IN THE MATTER of a submission by **AMBURY PROPERTIES LIMITED** on the **PROPOSED WAIKATO DISTRICT PLAN** pursuant to Clause 6 of Schedule 1 of the Act seeking the rezoning of land at Ohinewai

**JOINT WITNESS STATEMENT OF EXPERTS IN
RELATION TO TRANSPORTATION EFFECTS**

Figure 1: Possible path link to Ohinewai Hall (yellow broken line) (Figure 33 snipped from the Updated ITA)

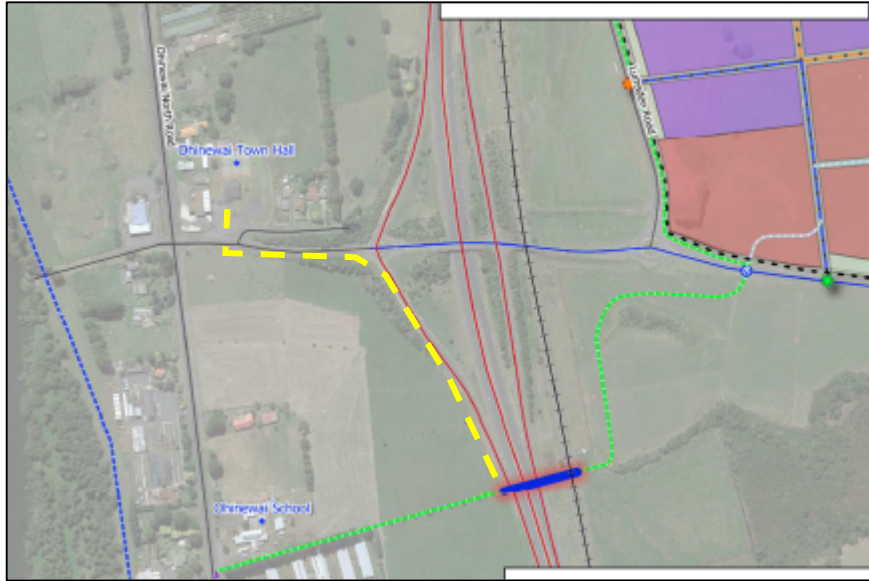
27. For active modes trips between the Ohinewai Hall and the Ohinewai Structure Plan (OSP) area, using the proposed bridge is expected to be undesirable because of the additional distance⁶ a pedestrian would need to walk compared to a direct route along Tahuna Road. There is a risk of pedestrians and cyclists using the most direct route, along Tahuna Road, which does not provide footpaths and does not have adequate shoulder width to safely accommodate cyclists. The provision of an additional footpath along the northbound off-ramp and along Tahuna Road (Figure 1 below) would reduce the distance for walking and cycling between Ohinewai east and west and may be a more attractive route for people traveling by active mode. This link would also have benefits for pedestrians walking to the existing WRC bus stop on the western side.

46. As discussed above in paragraph 27 there are likely to be trips made by walking or cycling between Ohinewai west and the proposed development to access bus stops, community facilities, employment, shopping and recreational areas. I agree that the proposed walking/cycling bridge over SH1 is well connected to the school. However, I consider that a more direct link to the existing residential properties, bus stop and the Ohinewai Hall is needed to provide a safe and attractive connection that avoids pedestrians walking along Tahuna Road to reach the Ohinewai Structure Plan area. There are no dedicated walking and cycling facilities along Tahuna Road or Ohinewai South Road and the proposal significantly increases traffic.

Figure 5: Pedestrian crossing facility on Tahuna Road to the east of the Tahuna Road / Lumsden Road intersection (source: extract from Drawing number 145860-08-0221, Appendix B, ITA)

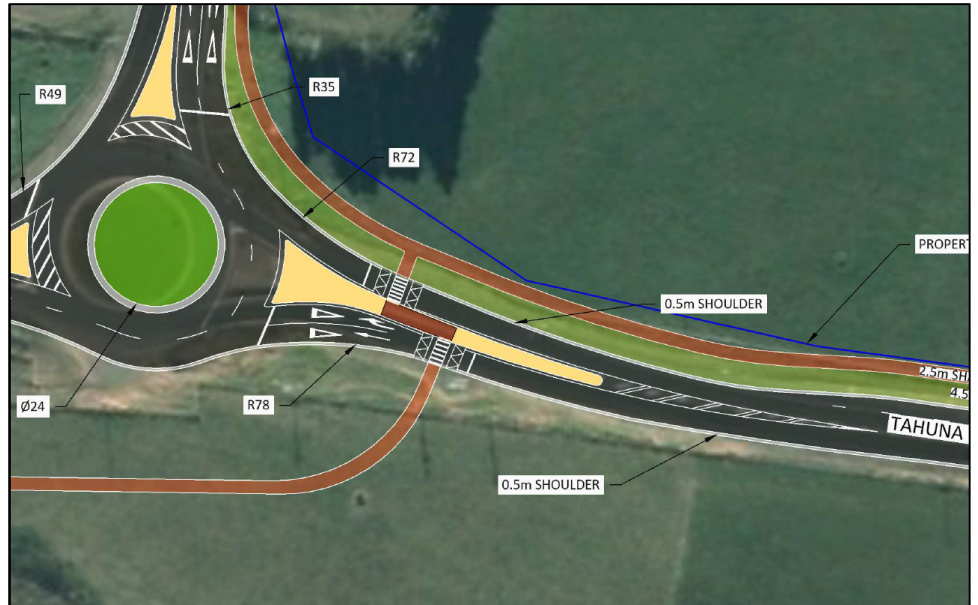
- 6.15 Drawing number 145860-08-0221 in Appendix B of the ITA illustrates the LTI / LTO intersection referred to above; it also illustrates a pedestrian crossing facility near the Tahuna Road / Lumsden Road roundabout (refer to Figure 5 below).

- 6.16 However, the location of the pedestrian crossing facility and shared path with which it connects appears to conflict with the left turn in access for the service centre (refer to Figure 6).

- 6.17 In my opinion, additional analysis is required to either reduce the number of intersections along Tahuna Road and / or to reconfigure those intersections to reduce the potential for adverse effects associated with movements to and from the Site. In addition, I consider further analysis is needed to address the apparent conflict between the pedestrian crossing facility and the left turn in access to the service centre.
